SERVICE BULLETIN

SUBJECT: Creaking Sound When Operating Clutch Pedal

NUMBER: 12-215-17
DATE: 01/20/17

OLD Style Part

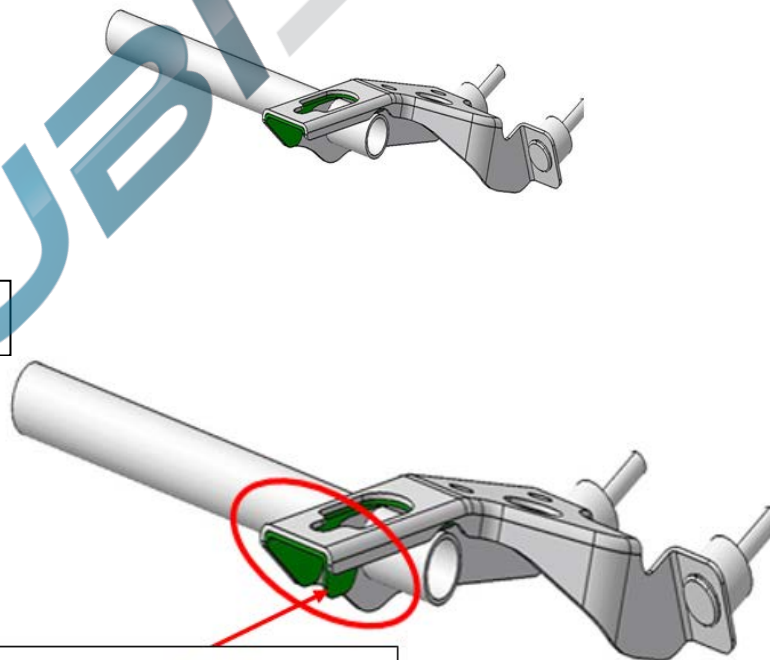
The flange area (shown in GREEN) has been extended and additional welding added.

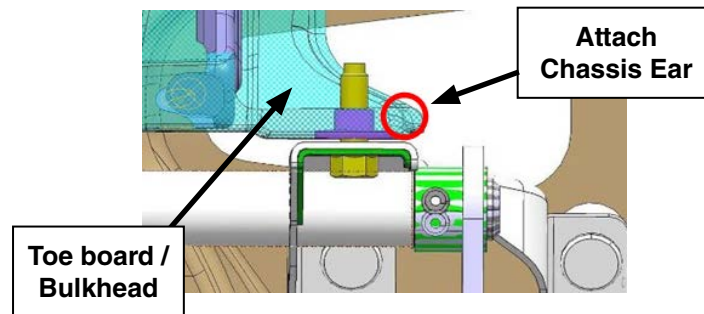
Once the sound has been verified, attach a chassis ear to the toe board / bulkhead in the location circled in the illustration below then operate the clutch pedal.

If the sound is confirmed to be originating from that location, replace the brake / clutch pedal assembly with the new part from the table above. Follow the procedure in the applicable Service Manual for replacing the pedal assembly including the additional critical points listed below:
